LAGI 2019 Abu Dhabi Q+A: Version 6 (April 21, 2019)

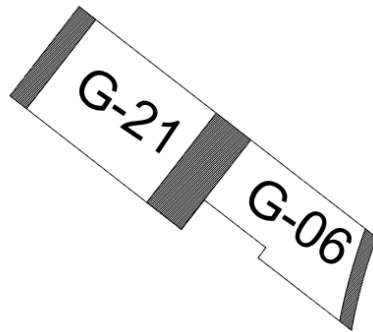
35. Q: Regarding to the site boundary, is there any flexibility in propose something that will be outside, or do we strictly have to contain our proposal within?

A: Please stay within the site boundary unless there is a very good reason to propose something outside of it. Your submission will only be judged by that which is within the boundary.

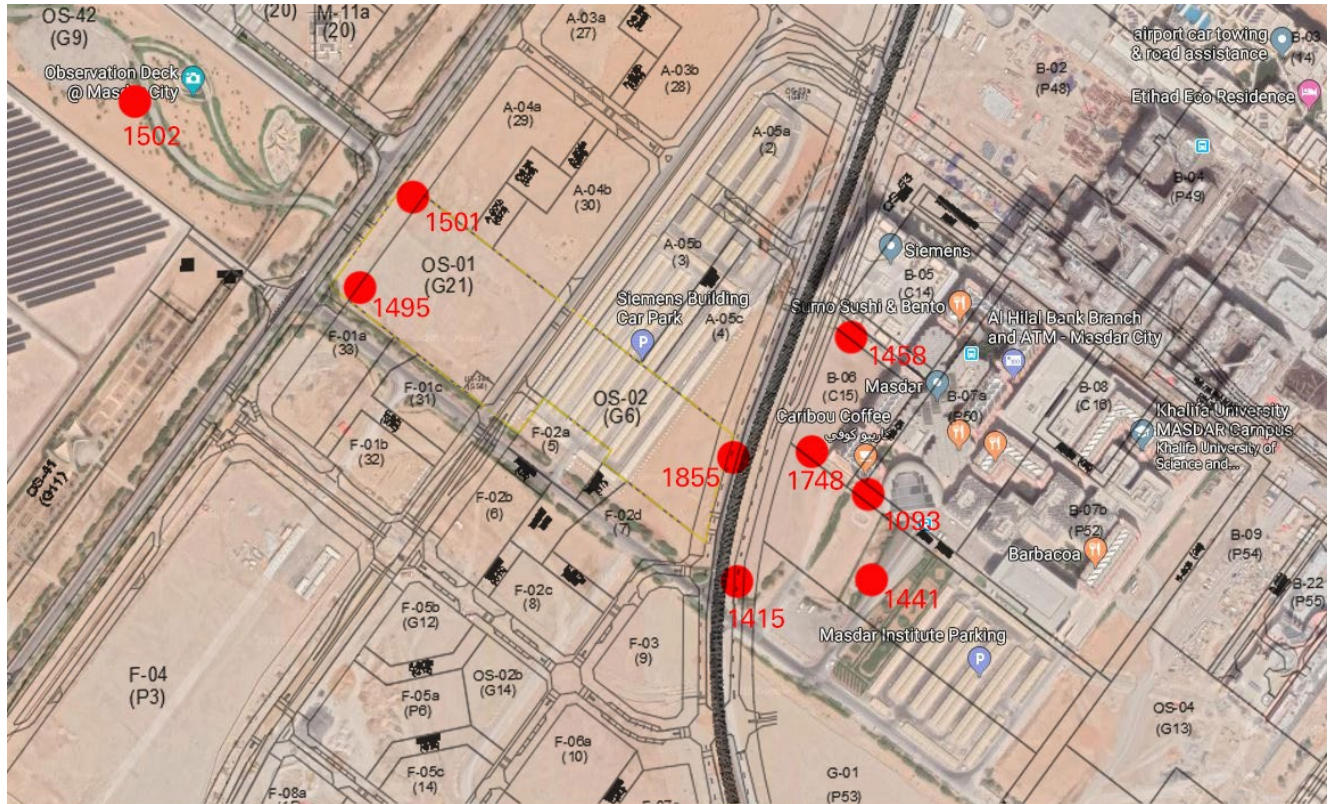
37. Q: Are the hatched areas in the attached image below included in the total area of the site or not?

58. Q: In question No. 37 you have answered that the hatched areas are included in the site boundary. Do you mean that the two areas on the edges of the site plan are inside the boundaries of the site or they are outside of the main site boundary?

A: The hatched areas in your sketch are included in the site boundary with the following important consideration. Please maintain 5-meter high clearance when the site boundary intersects with the street to maintain safe traffic flow. You may propose ground-level interventions within the sidewalk areas, making consideration for the safe passage of pedestrians.

A: The hatched areas on the two side edges of the site represent pedestrian sidewalks that are included in the site boundary. The actual road surface (everything beyond the curb) on those two sides are outside the site boundary. The entire road right of way that crosses through the middle of the site is within the site boundary as long as you maintain 5 meters clear height in that area for safe passage of vehicular traffic.
